39MT Starter Pinion Teeth Change for 2016 DD13/15/16 Engines (GHG17)

15-18

**Freightliner
Service Bulletin**

Fig. 1, Label for 39MT Starters for GHG14 and Earlier (2015 and Older) Engines

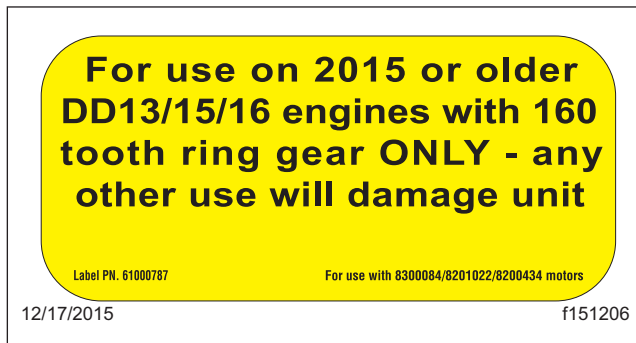
Beginning January 1, 2016, to improve starter engagement, the number of teeth on 2016 DD13/15/16 engines and applicable 39MT starters has been reduced. On 2016 and newer DD13/15/16 engines, the ring gears have 150 teeth, and the starters have 11 teeth. 2015 and older engines have ring gears with 160 teeth and starters with 12 teeth. Starters for 2015 engines must not be used on 2016 engines, and vice versa.

Delco Remy is labelling 39MT starters according to the correct engine application to assist in quick identification. See [Fig. 1](#) and [Fig. 2](#). An identification label will be affixed to the starter housing, and another beside the part number label on the starter packaging.

NOTE: Starters already manufactured and currently in circulation will not be retroactively labeled. Before replacing the starter, always verify it is the correct one for the engine.
